# HI-STORM 100 Amendment 18 RSI Clarification Meeting

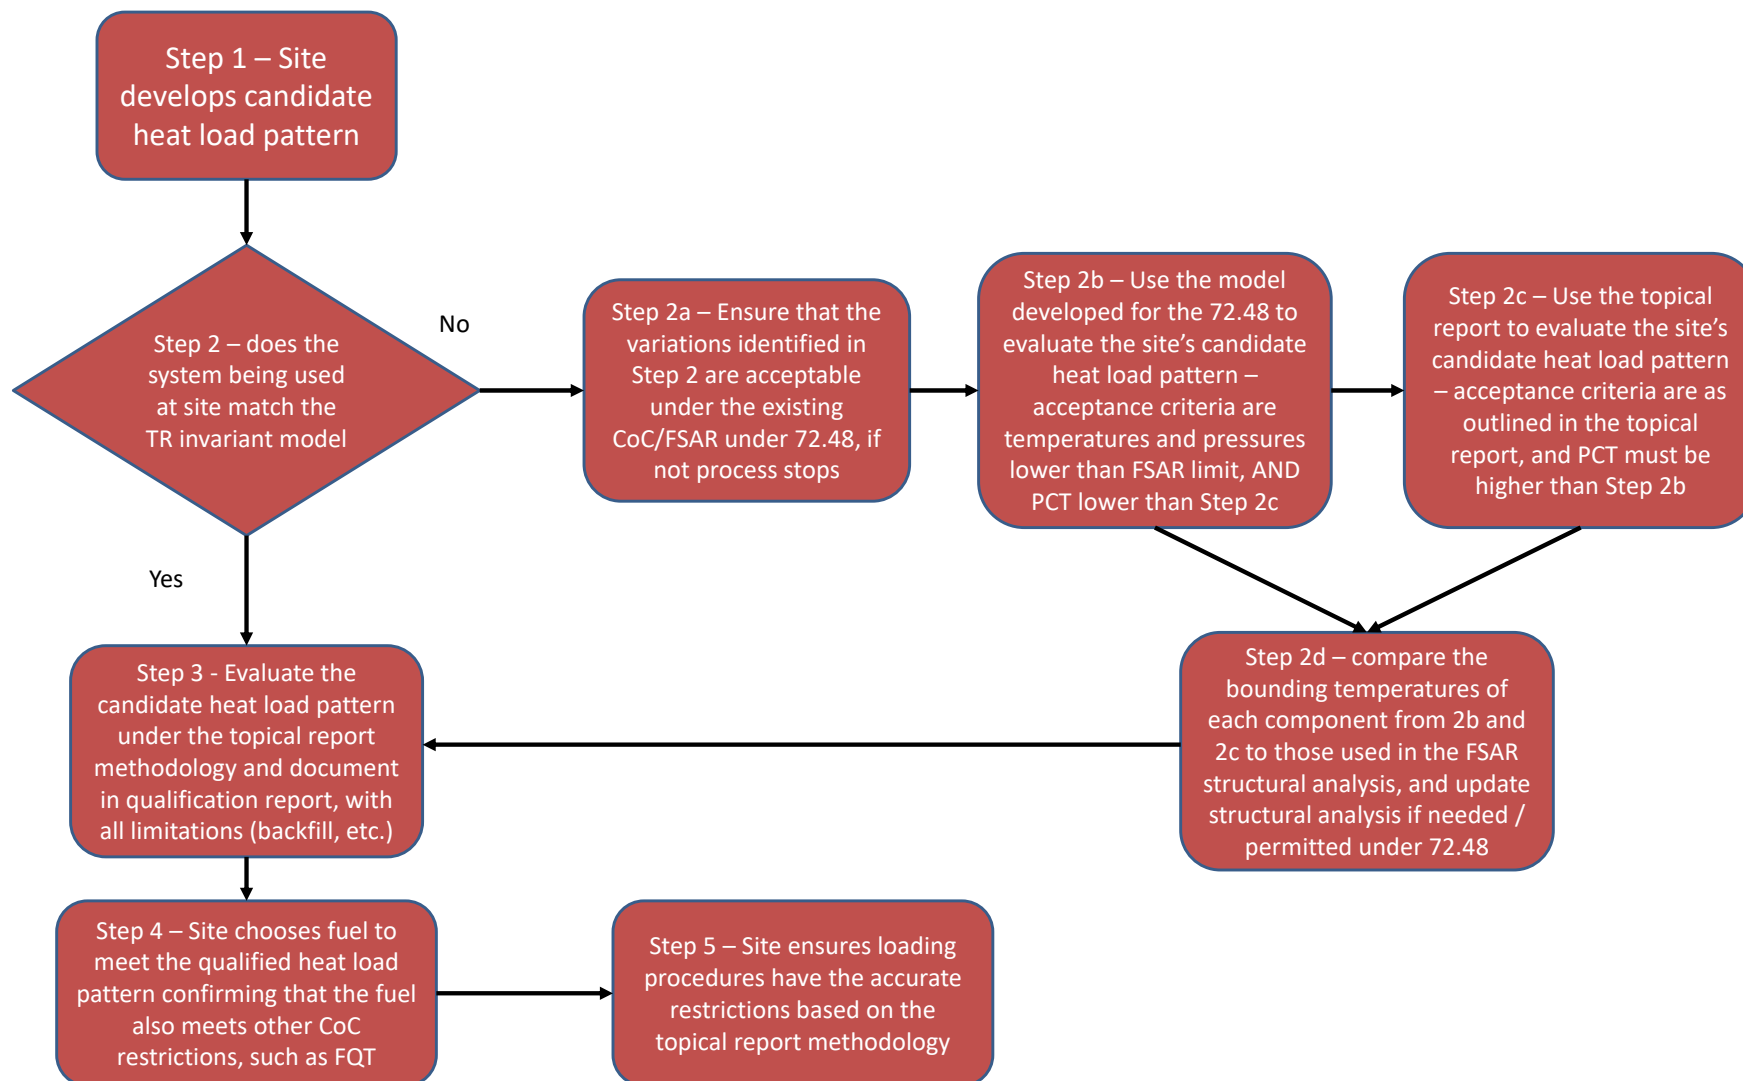
- RSI asks for more description about the flow chart added in Figure 1.0.1 of the SAR and specifically about the limitations in the SE for the topical report
- Holtec understands that the topical report has SE limitations, but wanted to find a way to not supersede the 10CFR72.48 regulation which applies to the FSAR
- Holtec has a proposal to modify, such that the final qualification of any heat load pattern is performed using the invariant topical report model
- Previously the plan was to show that the “72.48 model” was bounded by the topical report model, and use the “72.48 model” for qualification of heat load patterns
- Revised proposed approach will show the “72.48 model” is bounded by the topical report model and use the topical report model to do the final qualification of the heat load patterns

- Step 1 – Site decides the existing CoC heat load patterns do not meet their needs, and develops a new pattern that would meet fuel loading needs
- Step 2 – Site / Holtec determine if the system being used matches the invariant model in the topical report
  - ✓ If yes, then proceed through the qualification process outlined in the topical report, ensure all Topical Report acceptance criteria are met, and rejoin at Step 3
  - ✓ If no, follow Steps 2a through 2d
  - ✓ NOTE – the system being used must still fall under one those listed in the Topical Report SE, just may have some variation within those models

- Step 2a – Ensure that the variations from the topical report invariant model (identified in Step 2) are acceptable without NRC approval under the existing CoC / FSAR
  - ✓ This process is identical to Holtec’s existing 72.48 program and should be documented accordingly, which develops a “72.48 model” for that variation
  - ✓ If not acceptable, submit to NRC for approval
- Step 2b – Once the variations have been determined acceptable under 72.48, the site’s candidate heat load pattern should be evaluated in the “72.48 model”
  - ✓ This calculation must show that all components have a lower temperature than the FSAR limits and pressures lower than the FSAR limits
  - ✓ The PCT from this analysis is then compared to Step 2c

- Step 2c – The candidate heat load pattern is then fully qualified for use by evaluation in the Topical Report “invariant model”
  - ✓ This evaluation must show ALL Topical Report acceptance criteria are met
  - ✓ This evaluation must show a higher PCT than Step 2b
  - ✓ If either of these conditions is not met the candidate heat load pattern must be revised
- Step 2d – The temperature results from Steps 2b and 2c are compared to the structural evaluations in the FSAR
  - ✓ If FSAR structural evaluations use temperatures that bound the calculated temperatures, no further action
  - ✓ If FSAR structural evaluations use temperatures that do NOT bound the calculated temperatures, an additional 72.48 must be performed to demonstrate the new temperatures are acceptable without NRC approval
